Proposed Compensation  
for Cutting Centre  
Keelson  
S.S. Princess Louise

Get report No 13287

PROPOSED COMPENSATION FOR CUTTING  
CENTRE KEELSON S.S. PRINCESS LOUISE

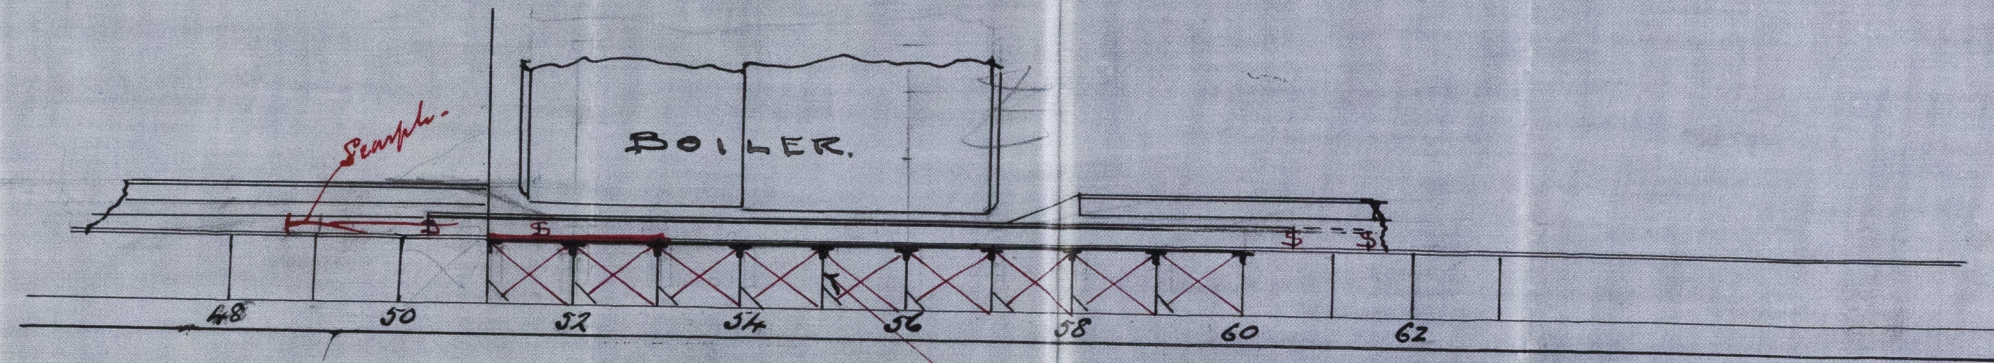
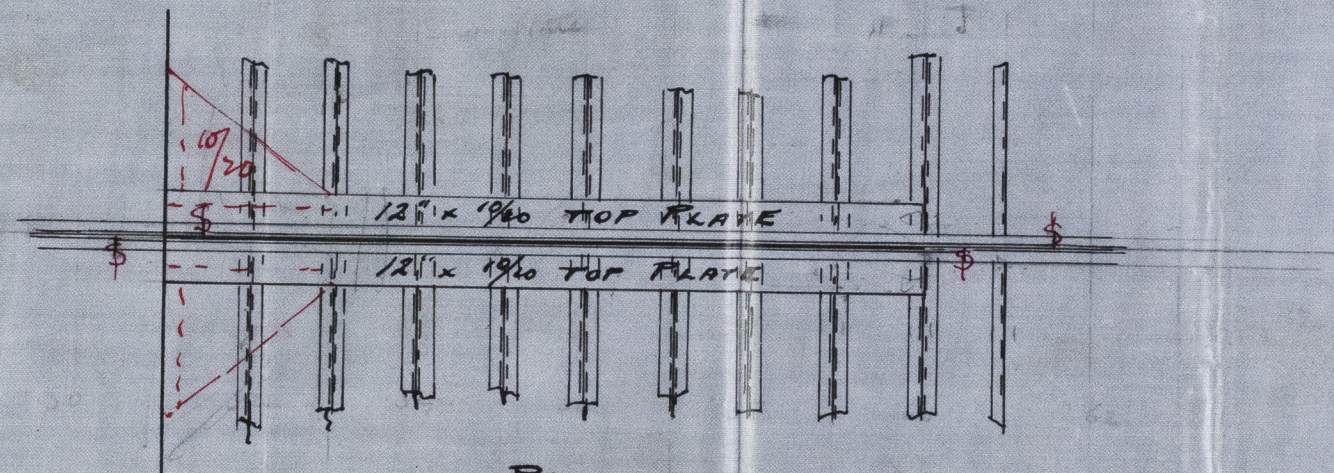
OWING TO POSITION OF  
BOILER IT IS IMPOSSIBLE  
TO FIT A DEEPER ANGLE DOUBLE ANGLES  $4 \times 4 \times \frac{13}{20}$ "
